Transformer replacements

UE RRP BUS 4.03 – Transformer
replacement – Dec 2020 – Public

Revised regulatory proposal 2021–2026

Figure 3.1 Illustrative example of relationship between maximum demand and energy at risk

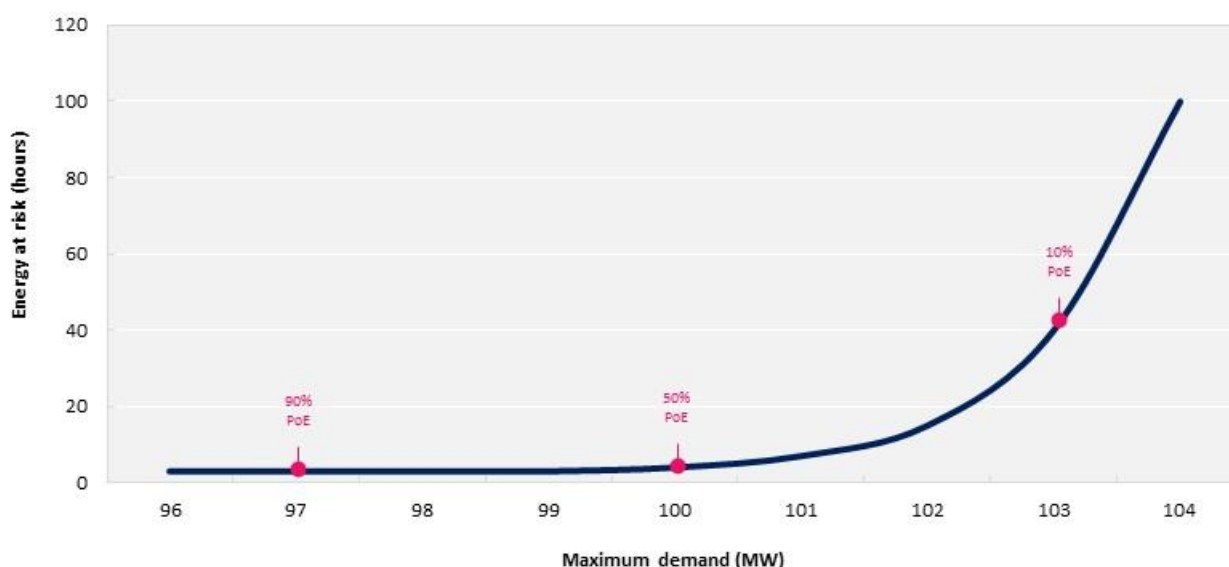
'EMCa noted that the use of this demand treatment in the context of assessing asset replacement timing may not be appropriate:

"We consider the key issue here is the application of a planning methodology to estimate the expected value of unserved energy. We consider that United Energy is incorrect in stating that the 50% PoE does not represent a realistic expectation of demand. However, the expected value of unserved energy is not a function of the peak demand alone. It should take account of the Load Duration Curve, since the amount of energy unserved (if any) as a result of an equipment outage depends on the load during the time of the outage, and this also is influenced by any mitigation measures...United Energy has not demonstrated that its 70:30 assumption is valid for DNSP planning purposes."

- through the draft determination and subsequent discussions, it appears the AER and EMCa believe we assume all failures occur at peak times (i.e. that we have not used a load duration curve to estimate our energy at risk). This is factually incorrect. Our risk modelling considers energy at risk, which is a function of both peak demand and the load curve. Specifically, our risk models look at the daily load profile over a whole year, which varies between summer and winter months, as well as having different shapes in both the 10th percentile PoE demand and 50th percentile PoE demand years. This approach is used for both planning and asset replacement purposes

- EMCa's recommendation to the AER is premised on the 50th percentile PoE being a realistic expectation of demand. We do not disagree, however it is not a realistic expectation of *unserved energy* (see next point). This is the parameter that drives the replacement outcomes and hence needs to be 'realistic'

- we have demonstrated that mathematically, a 100 per cent weighting on the 50th percentile PoE (as suggested by the AER) is not representative of expected unserved energy. The relationship between maximum demand and energy at risk is not linear and so using 100 per cent on the 50th percentile PoE demand significantly understates expected unserved energy and hence is not realistic—as illustrated in figure 3.1, although the 50th percentile PoE may represent the mean, the expected value of energy at risk will lie between the 50th percentile and 10th percentile PoE values

Figure 3.2 Actual and forecast transformer faults

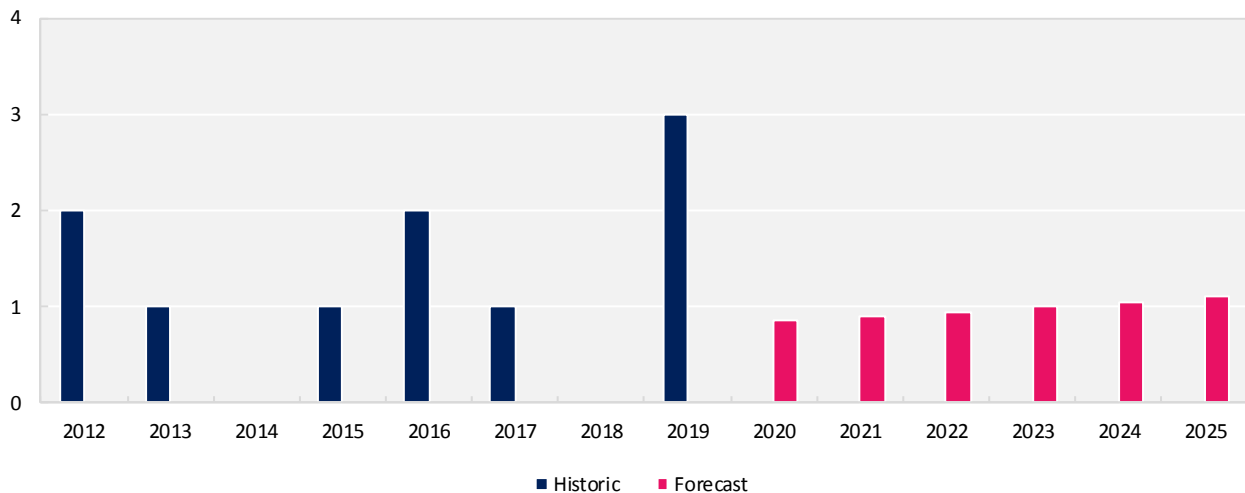
In our original proposal, we used a Kaplan-Meier (K-M) analysis to approximate the probability of a catastrophic failure. We then used a mixture of University of Queensland failure surveys and historic experience to approximate major and minor failure ratios. The AER questioned whether the University of Queensland failure survey only consider catastrophic failures causes rather than all failures.

We accept the AER's concern and have now updated our K-M model by considering historical fault data only.⁵ We have correspondingly updated our risk model inputs to align with recorded actual consequences (also refer to section 3.1.4 below, where we consider consequence costs) as attached to this addendum.⁶ By using all our failure data (i.e. both repairable failures and catastrophic failures), these updates have lowered the probability of a catastrophic failure and increased the probability of failure of a repairable failure. The results are outlined below.

We have validated the revised model output which shows the reliability curve results in a forecast fleet fault rate that correlates well with historic faults. Over the six-year period from 2014–2019 we experienced seven faults, and over a six-year forecast from 2020–2025 we predict around six faults. This is shown in figure 3.2.⁷

Figure 3.3 Testers and fitters available hours compared to transformer and switchgear program hours

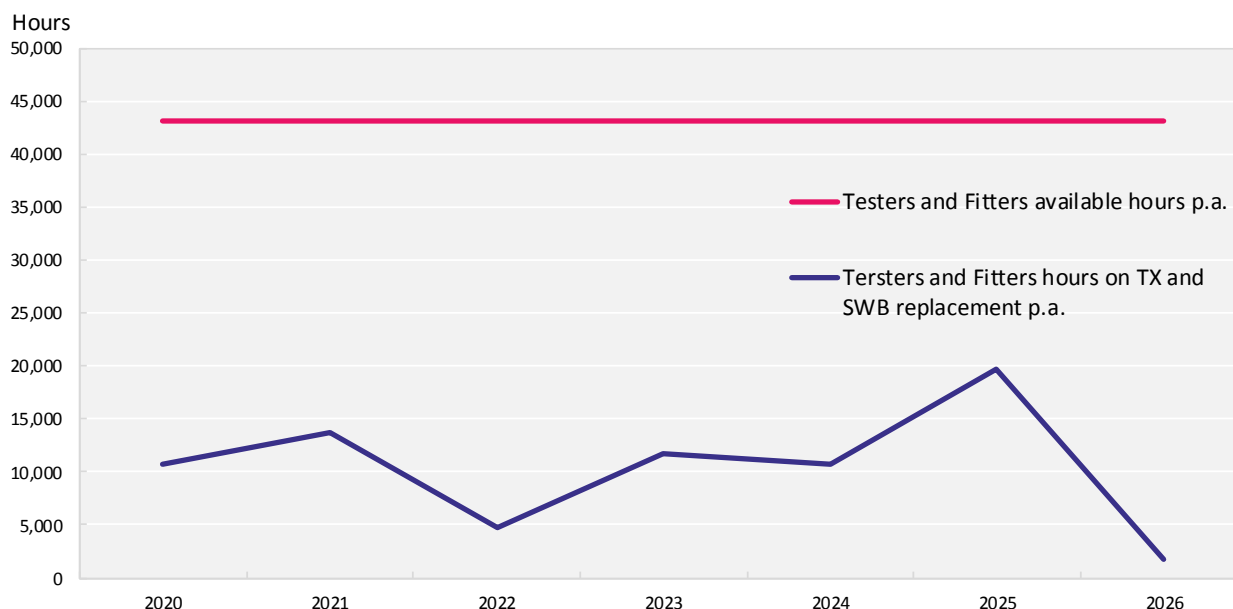
- evidence of actual failure consequence costs was not provided (including the impact of mobile transformers)
- deliverability concerns due to the scale of our proposed transformer program

This transformer program sits well within our delivery capability.

The greatest number of transformers we are proposing to commission in a year is three, in 2023. This is not a particularly large number of transformers—in 2017/18, we also commissioned three transformers.

We have an outsourced model where transformer works can be awarded to any resource partner on our panel. Typically, we use around eight testers and 16 fitters per year. This represents only a portion of the fitters and testers available to us through our resource partners.

Even within the typical workforce we use, this transformer program can be readily fitted within our works program. Figure 3.3 shows the workload of our transformer and switchgear programs combined—these represent the major work programs for typical fitters and testers workforce over the 2021–2026 regulatory period. It shows these major programs represent a modest workload for our typical workforce.
